Comments on EIA of Kangtanshiri HEP in Arunachal Pradesh by WAPCOS

The 80 MW Kangtanshiri HEP on Yargyap Chu river (a tributary of Siyom river, which in turn is tributary of Siang River in Brahmaputra basin) is to be considered for EC by EAC of RVP in Nov 11-12, 2013 meeting. Our comments on the EIA of the project done by WAPCOS are given below. These are preliminary comments; further comments would be submitted once full EIA-EMP-PH documents are put in public domain.

L Section of Yargyap Chu river as given as fig 3.3 in CWC study of Siang basin

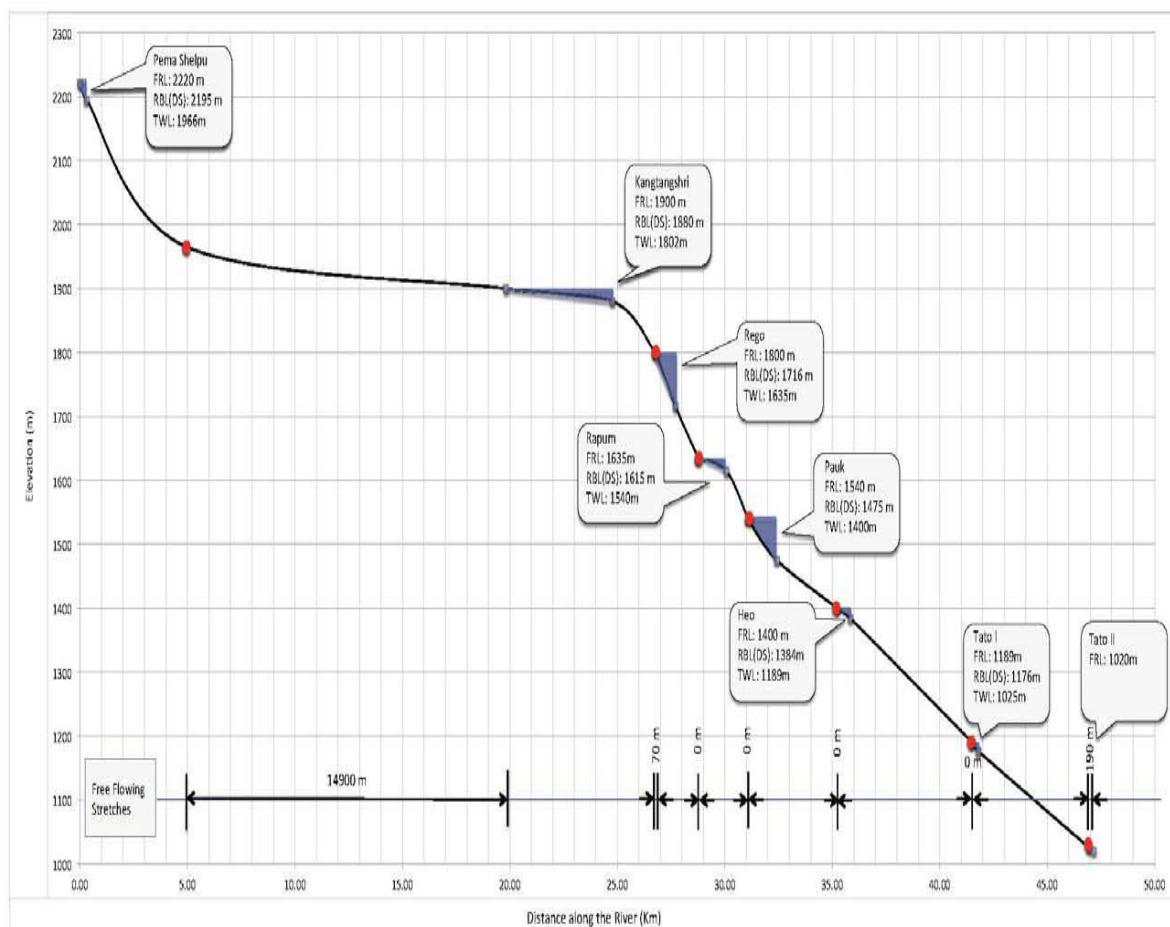
2. The Yargyap Chu River already has seven large proposed projects all of which have been given TOR ok by EAC, even when the project parameters were contrary to even the weak norms of EAC of at least 1 km distance between projects. In addition, there is Tato II project which also submerges part of this river. In addition there are at least two more projects of 12.5 and 15 MW on tributaries of Yargyap Chu, also having substantial impacts. As things stand now, there is zero distance between several of these adjacent projects. Even between Kangtanshiri and next downstream project, namely Rego, there is just 70 m of river as shown in L section from CWC report shown above. This is clearly not adhering to even the bare minimum norms of EAC. The EC for Kangtanshiri project should not be considered till the distance is increased to at least 1 km as per the norms followed by EAC now (these norms too need to change to increase this distance and also adopt other necessary norms).
